DeKalb County Historic Preservation Commission

Staff Report

A. 868 Artwood Road, David Neuman. Removal of trees, modification of driveway, and installation of retaining walls, pool, patio, landscaping, and fencing on the rear of property. **1248235.**

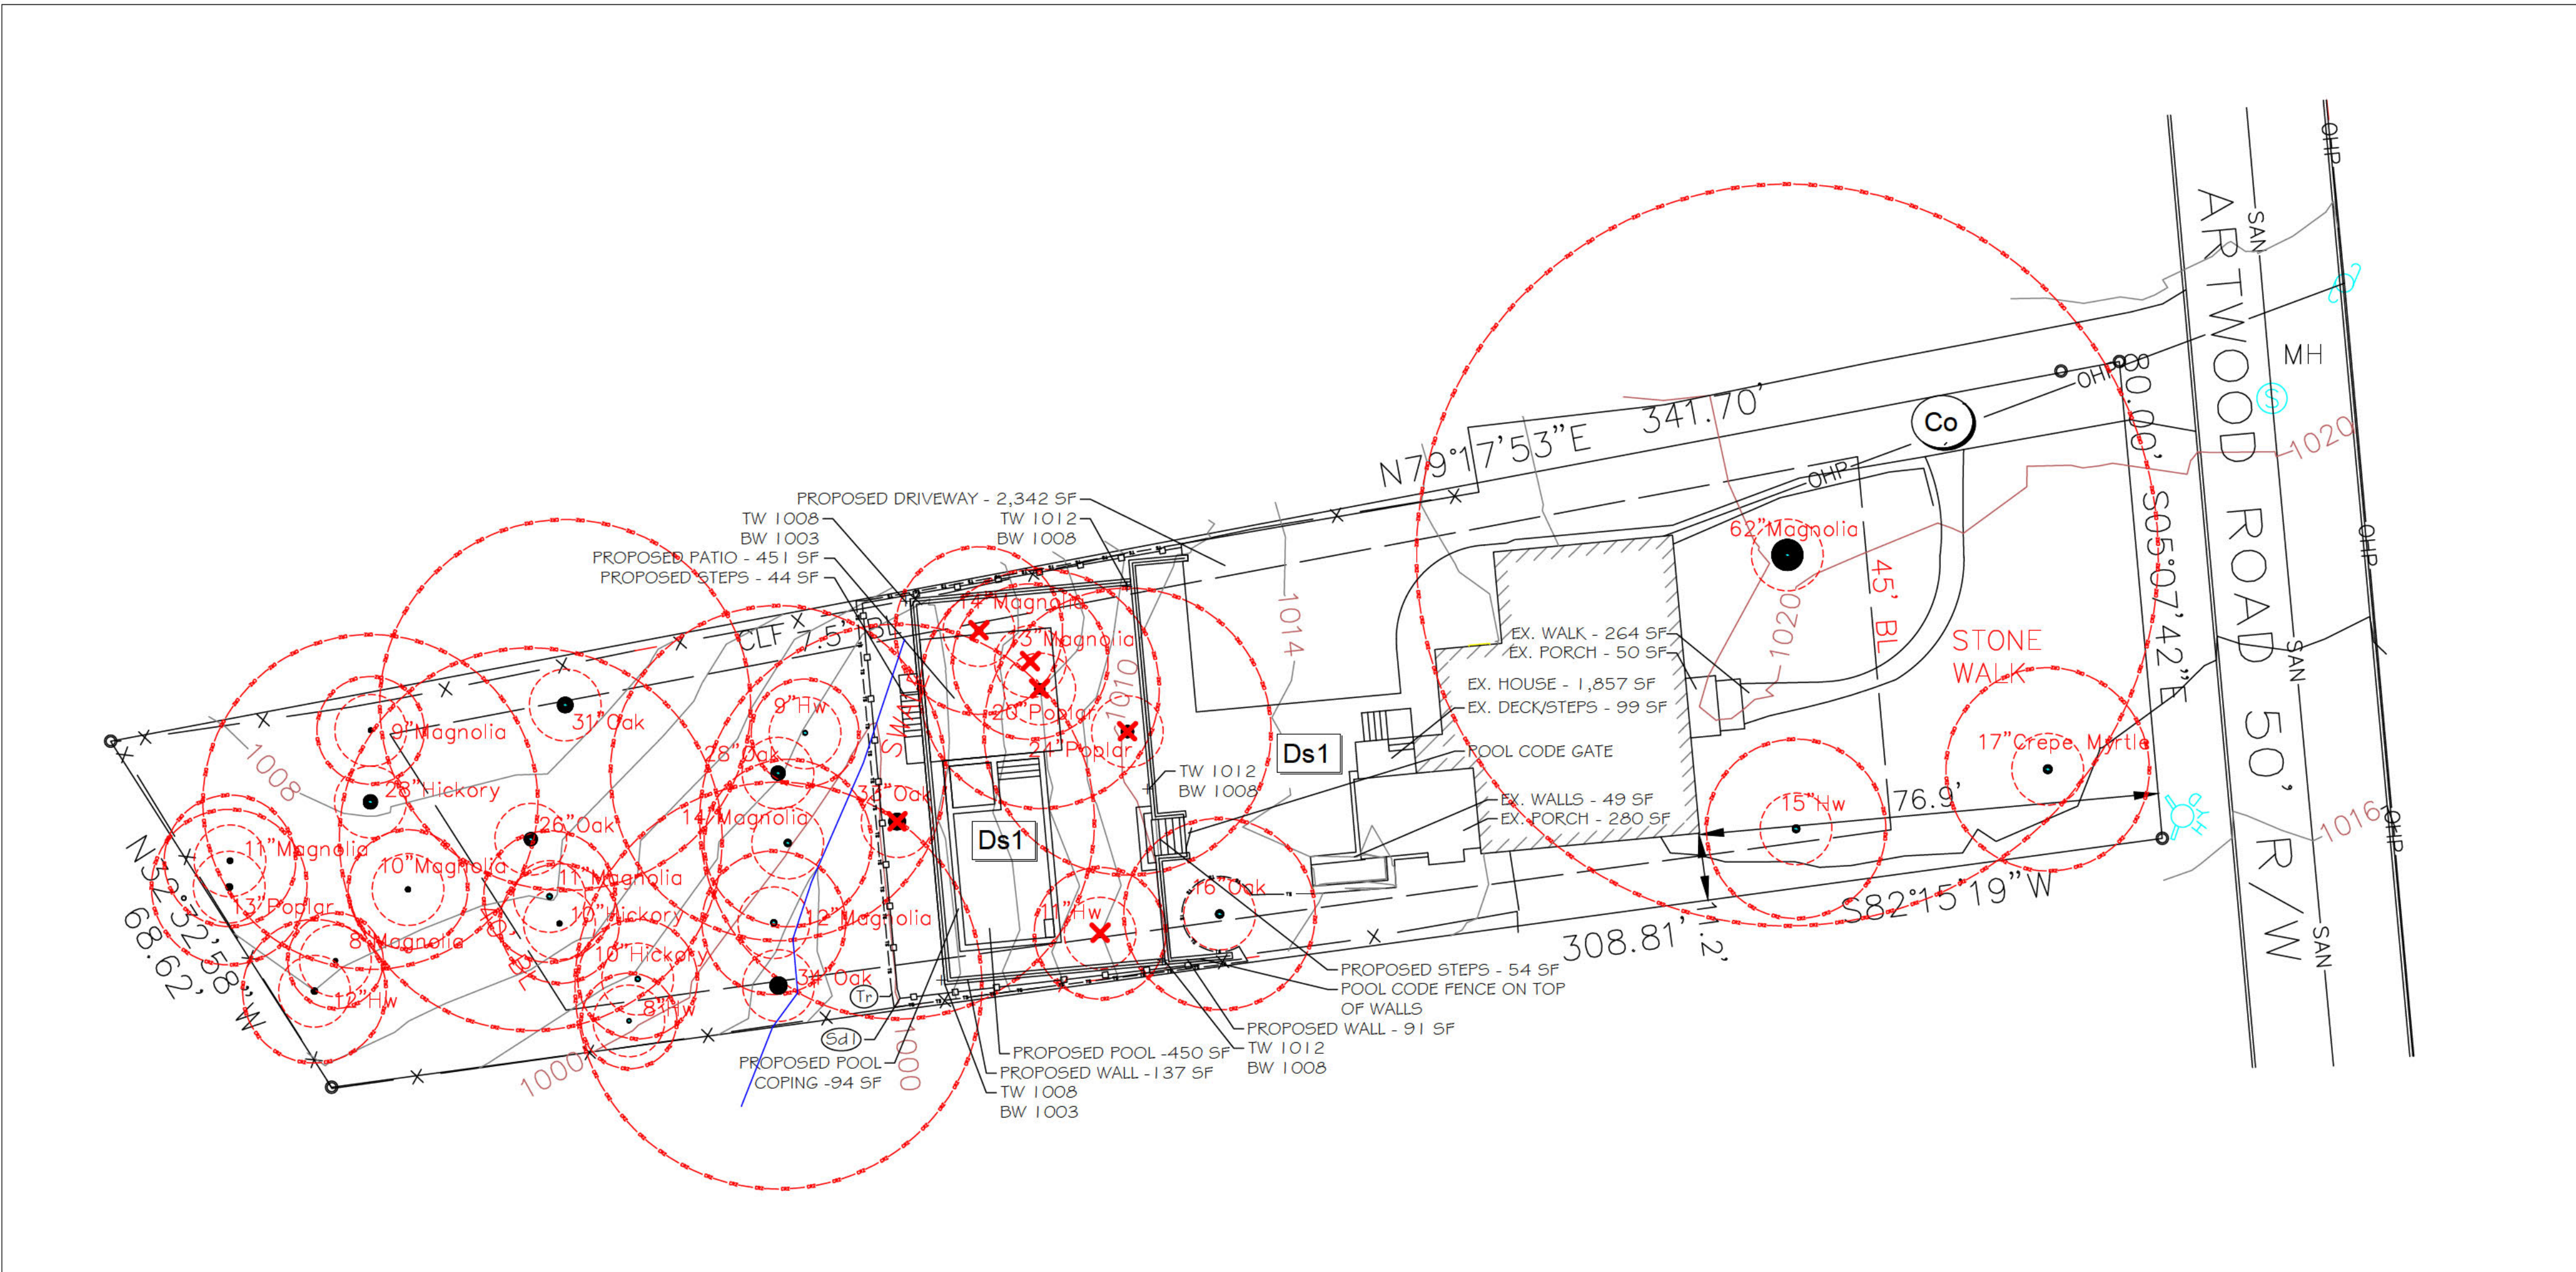
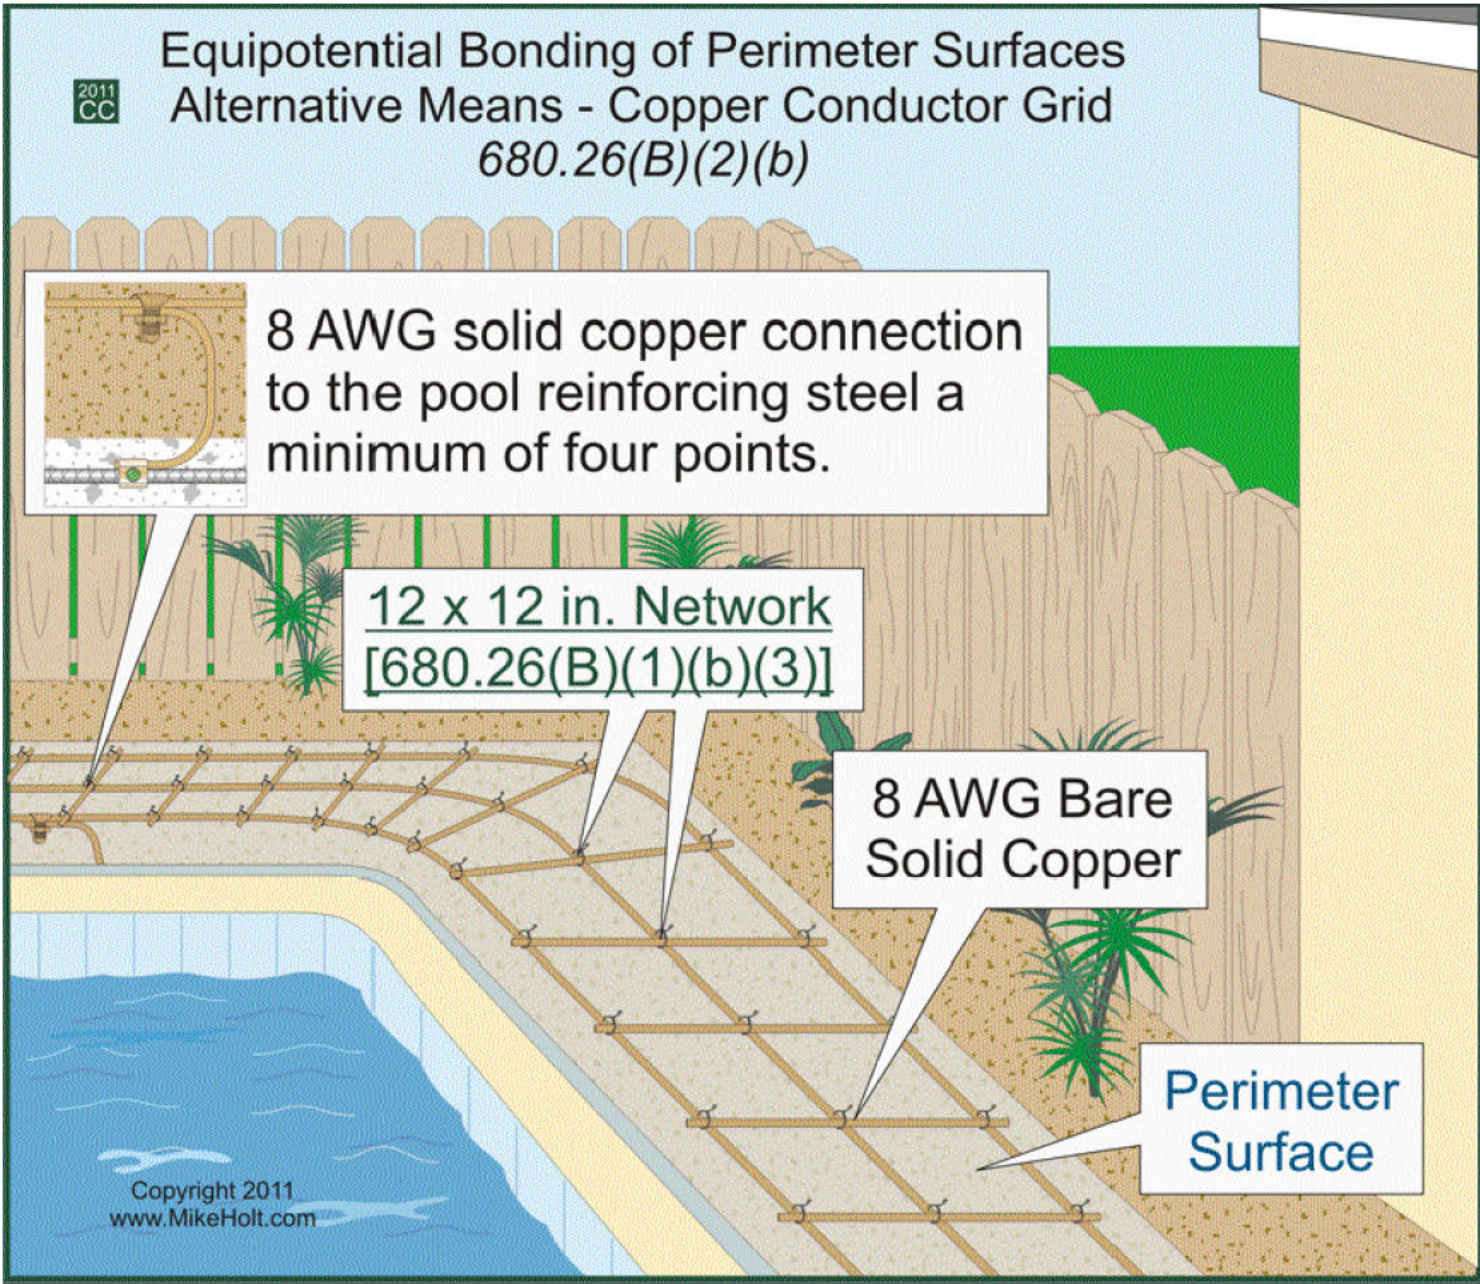
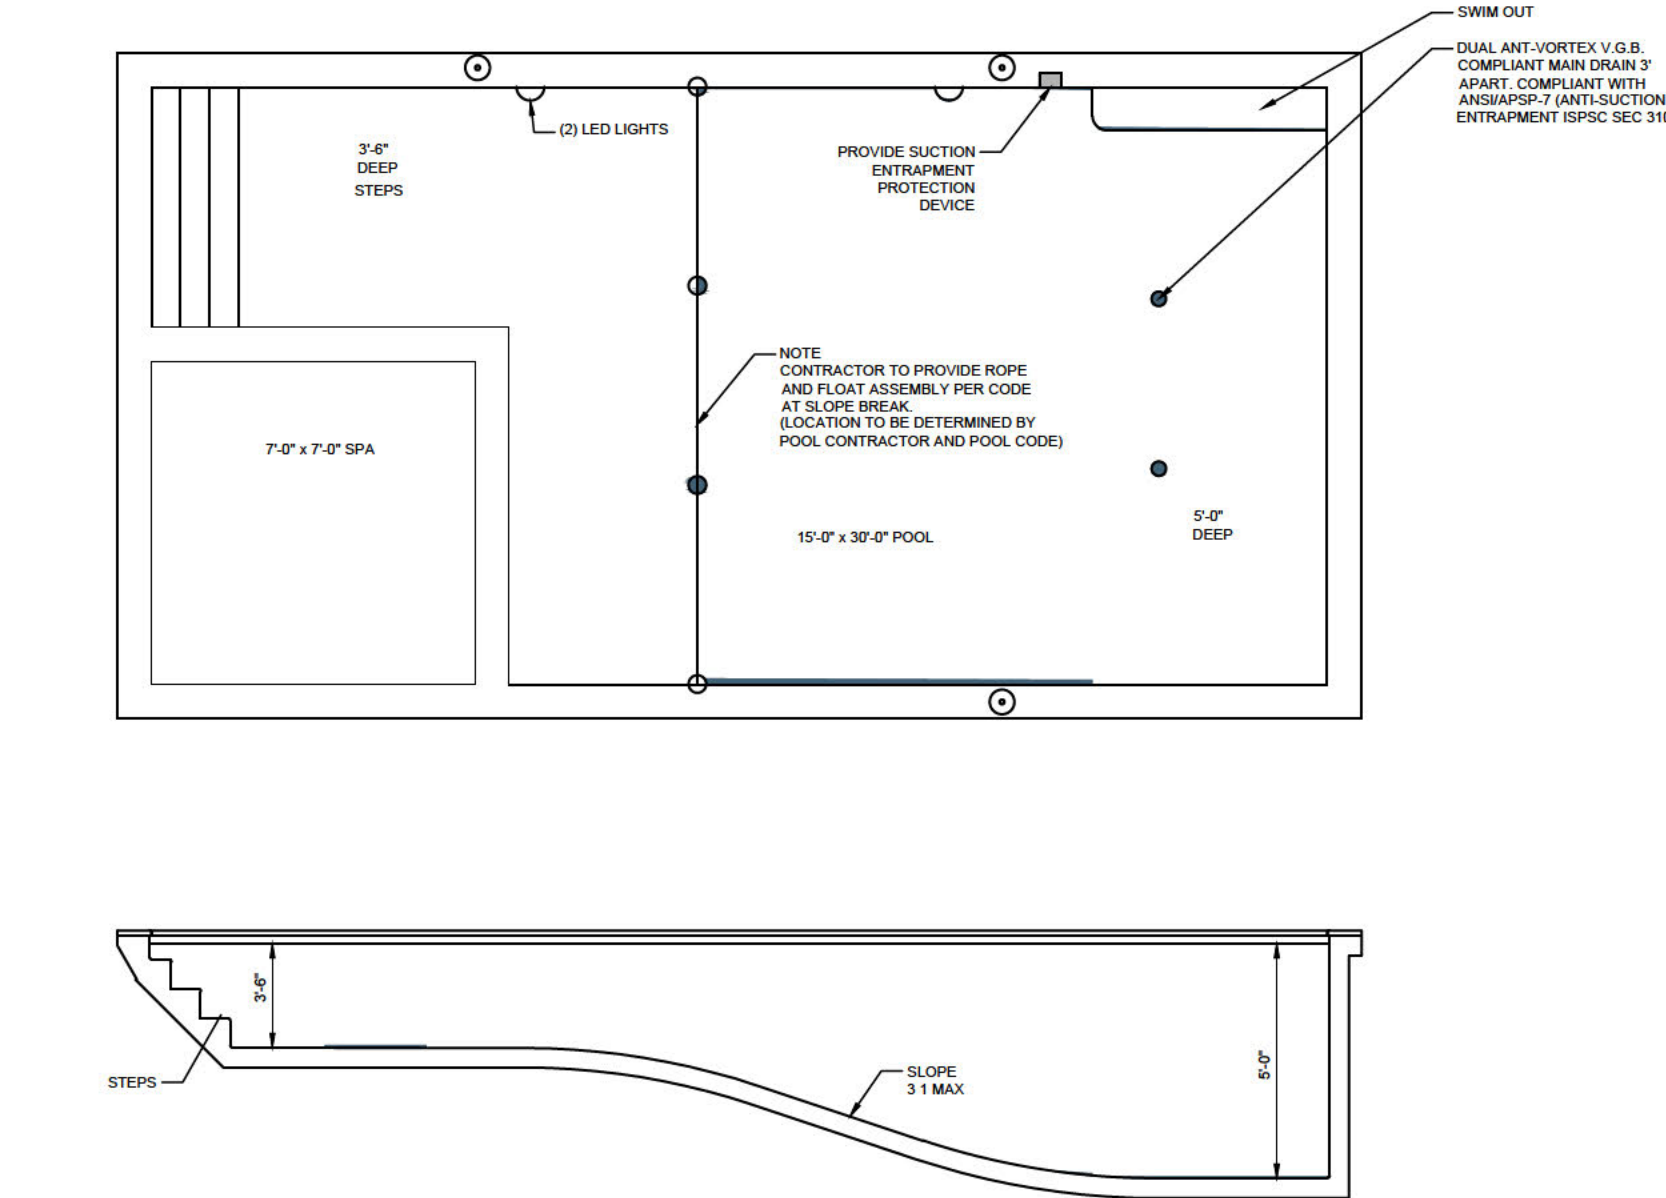
Due to proposed height of the retaining walls on the property, a variance will need to be acquired from the Zoning Board of Appeals before a building permit can be issued, as the walls appear to exceed zoning requirements for retaining walls on single-family lots¹.

¹ **Section 27-5.4.7.D.3.** – "Retaining walls may be tiered but no single wall shall exceed four (4) feet in height. All tiered wall design shall be certified by a licensed engineer."

1. What are the heights of the proposed retaining walls?
2. What material is the existing driveway and what will be the material of the new driveway?
3. Will the driveway be expanded, relocated, or modified in size or shape?
4. The proposed fencing is listed as 4' in height, however, for the fence to fulfil the Health Code requirements for pool safety, the required height is 5'. Would you want to modify the proposed height of the fencing in the application to ensure that the code requirements are met?

1. The walls will be no taller than 6' exposed.
2. The existing driveway is asphalt and the new driveway will be concrete.
3. The driveway will not be modified in shape or size.
4. Yes, I would like to modify the height to 5'. Is that something that I need to revise and send to you or you will edit on our application?
